MIL-M-28787/44B
AMENDMENT 2
31 December 1992
SUPERSEDING
AMENDMENT 1
15 February 1985

MODULES, STANDARD ELECTRONIC

LATCH, DIGITAL, KEY CODE GBL

FIGURE 3. Operating temperature and life test circuit.

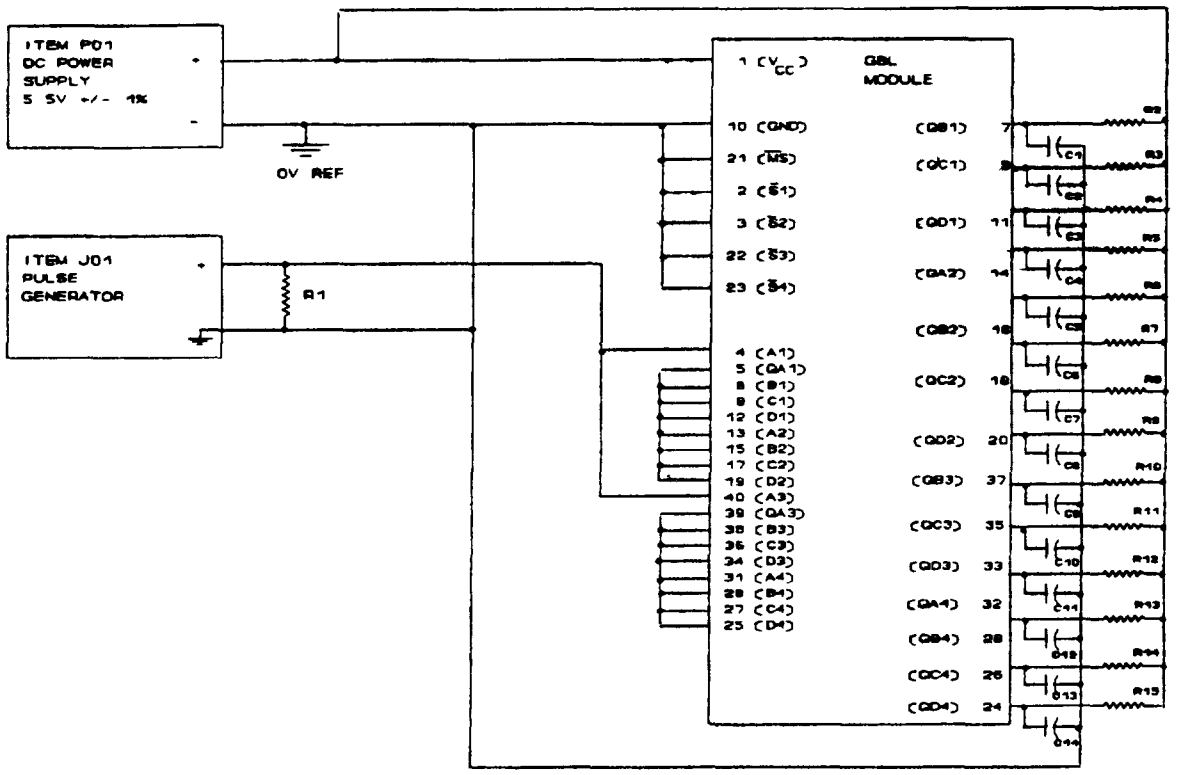
FIGURE 3: Delete and substitute new figure 3 as printed on page 3 of this amendment.

1. R1 = 50Ω ± 5%, 1 W.
2. R2-R15 = 1.43 kΩ ± 1%, 1/8 W.
3. C1-C14 = 100 pF ± 20%.
4. Input pulse parameters: PA = 4.0 ± 0.5 V.
   PW = 500 ± 50 ns.
   $t_{TLH} = t_{THL}$ = 25 ± 5 ns.
   PRR = 1.0 ± 0.1 MHz.
